**RE: U-Haul
2217 4TH St. NW
Grading & Drainage Plan
Engineer's Stamp Date: 04/20/20
Hydrology File: H14D110**

**RE: U-HAUL -2217 4TH ST. NW
GRADING & DRAINAGE PLAN
ENGINEER'S STAMP DATE 01/28/20
HYDROLOGY FILE: H14D110**

U-HAUL
4TH AND I-40
GRADING AND DRAINAGE
PLAN

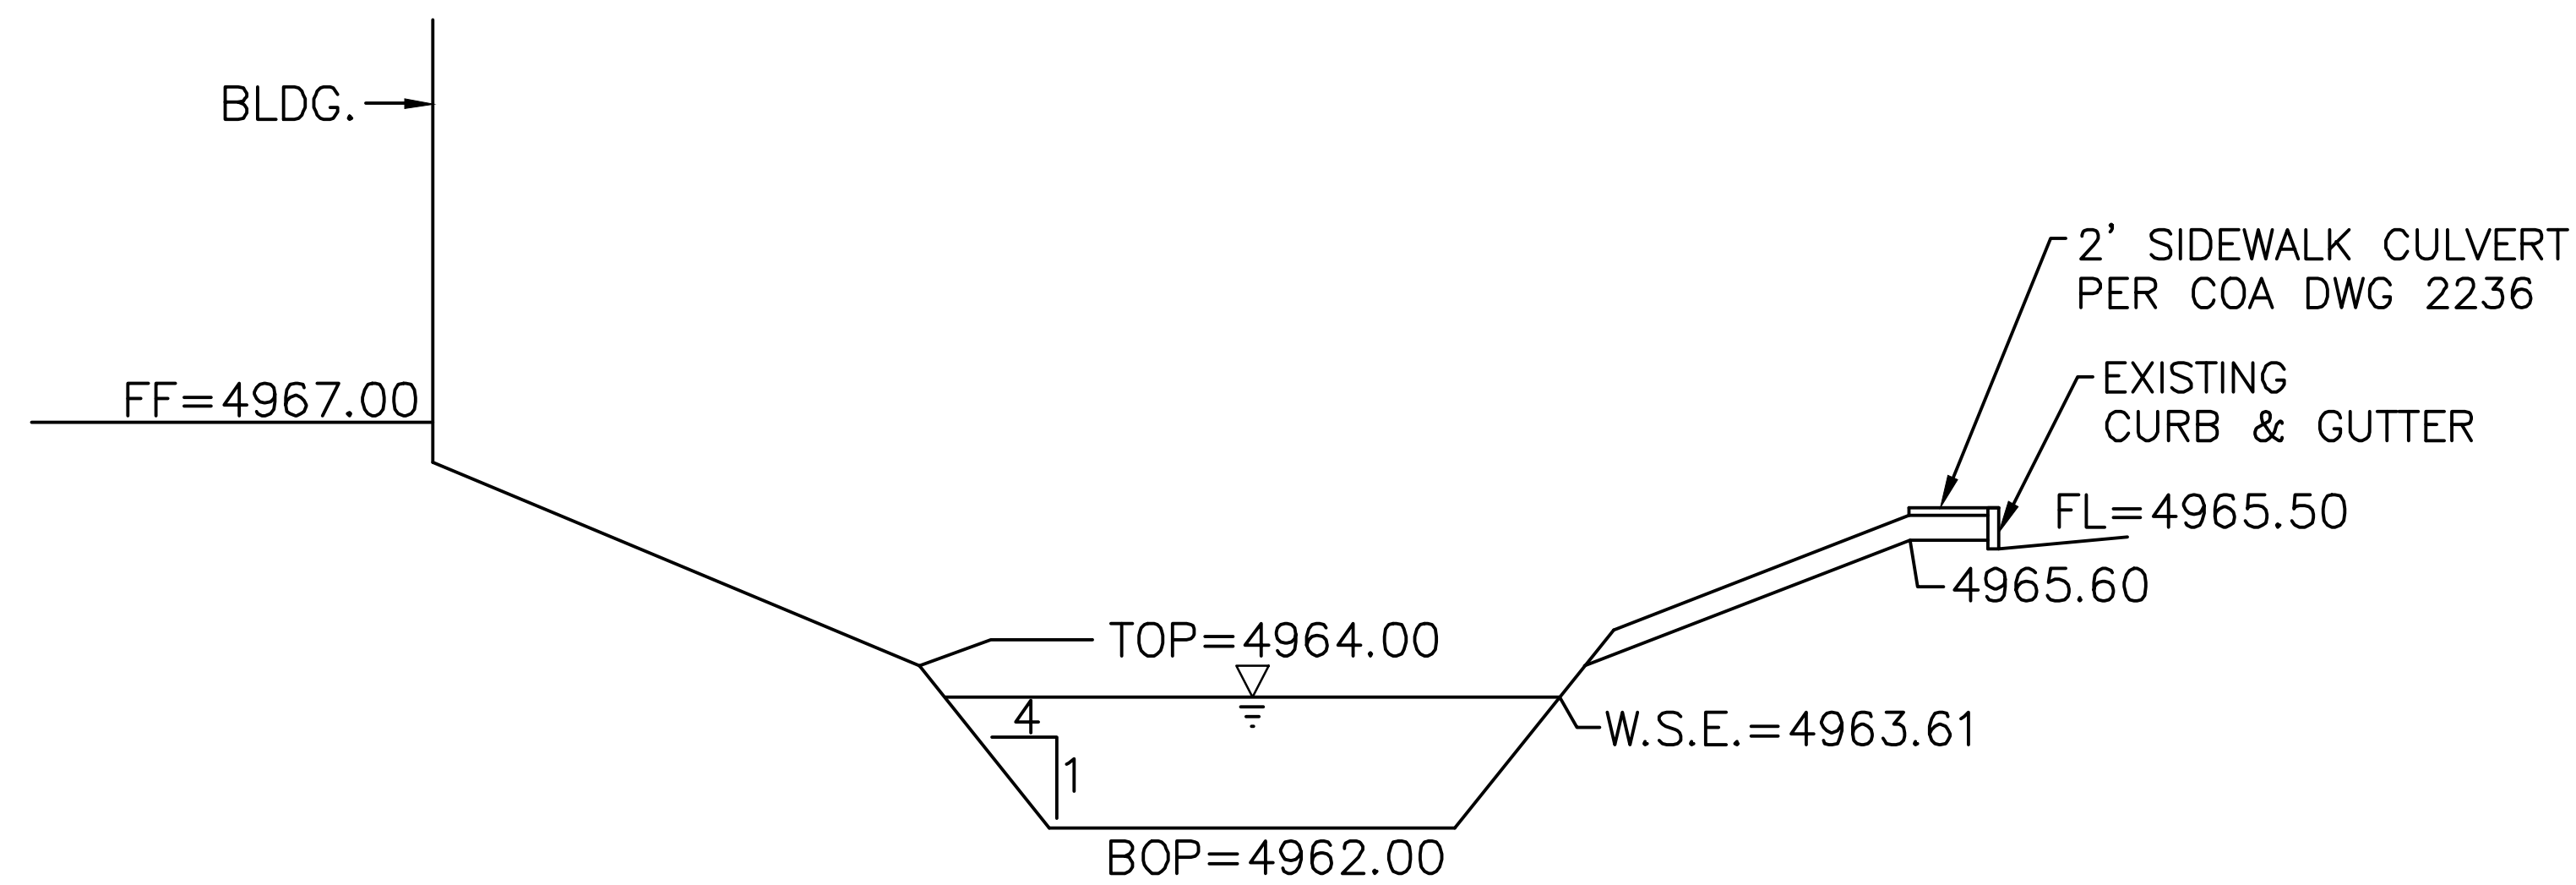
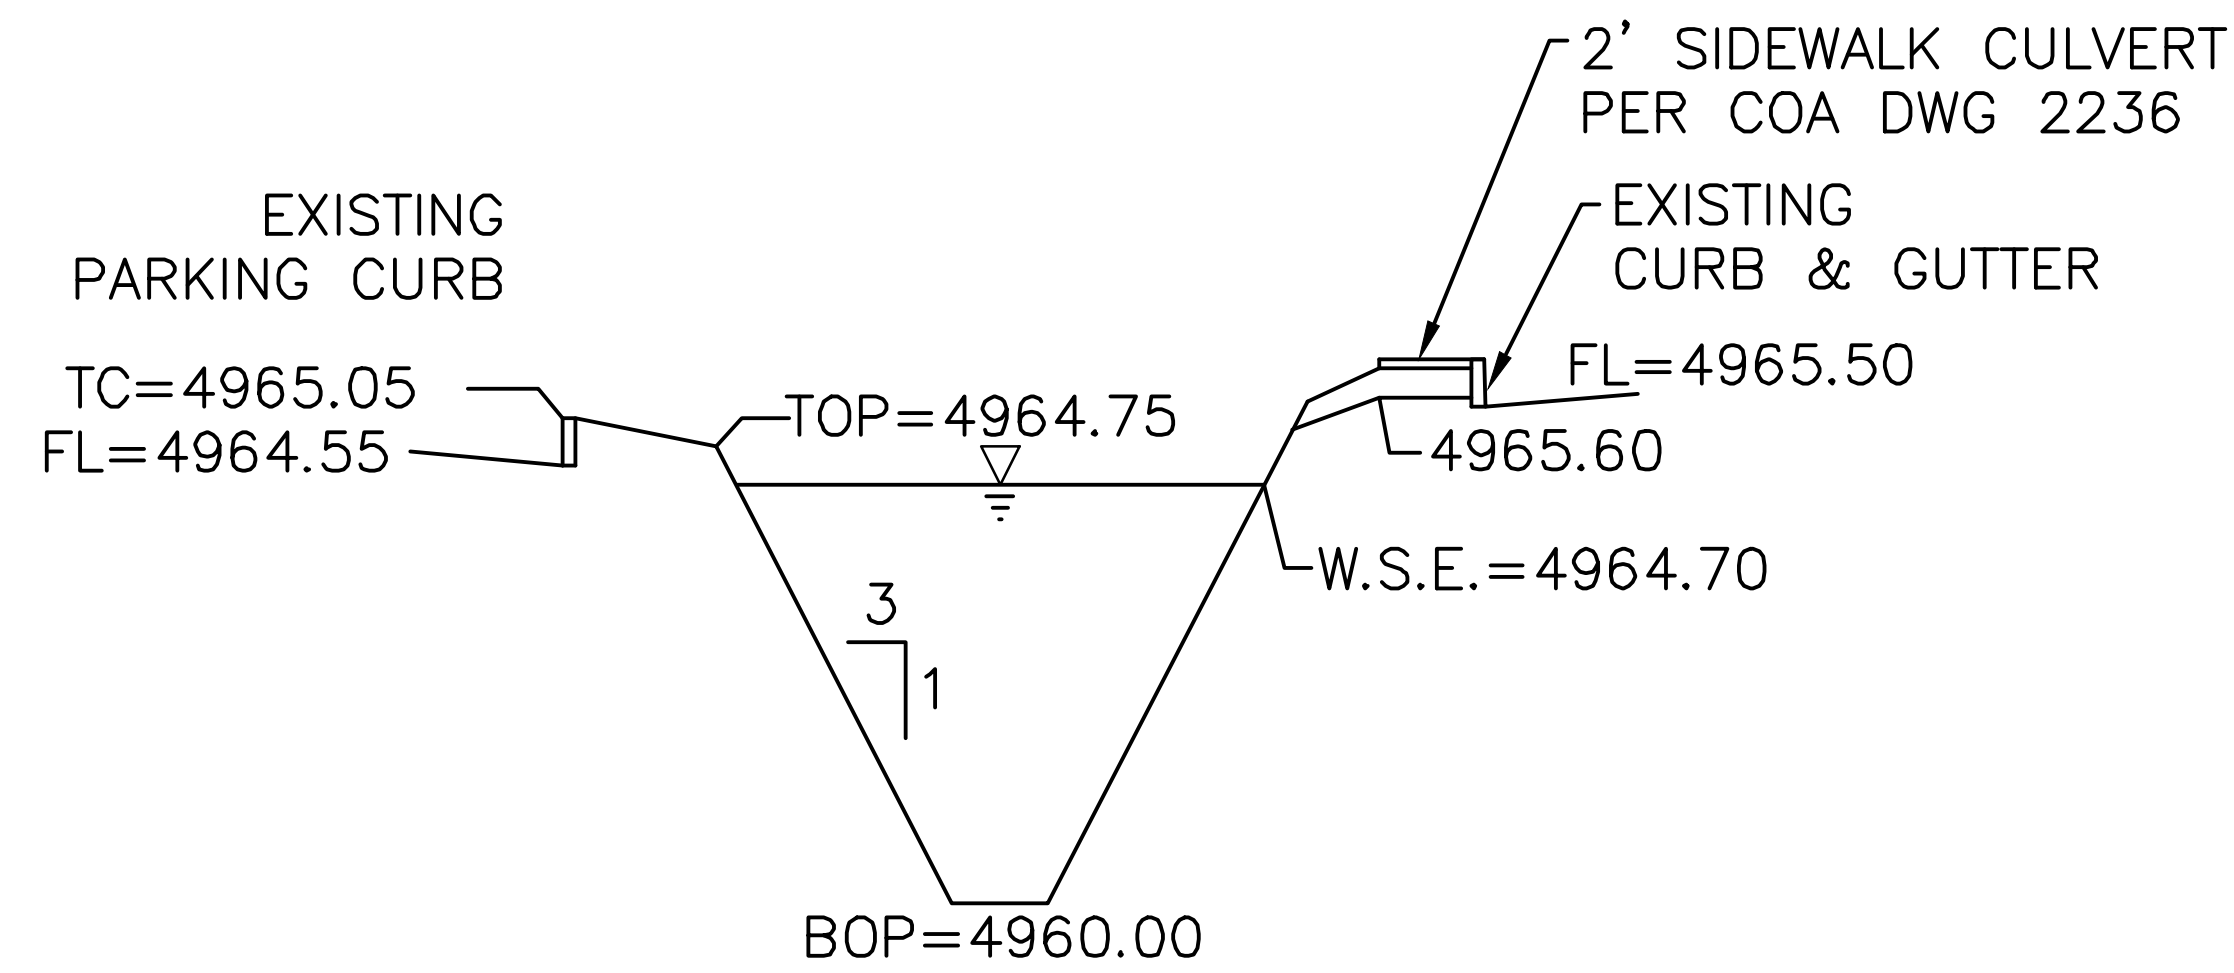
3. Please provide an emergency spillway for both retention ponds by way of sidewalk culverts.
Sidewalk culverts were added to both ponds and daylight onto 4th Street.

5. Please add the broad crest weir equation (equation 6.60 in the DPM) for the 2ft curb cuts and the sidewalk culverts. A coefficient of 2.7 is typically used for the equation $Q=CLH^{2/3}$.
The equation was added to the sheet for each rundown.

8. Please show and label the slump pump along with the force main. Also provide the cut sheet for the pump along with the performance curve.

The sump pump is labeled and a detail sheet with all of the pump information was created.
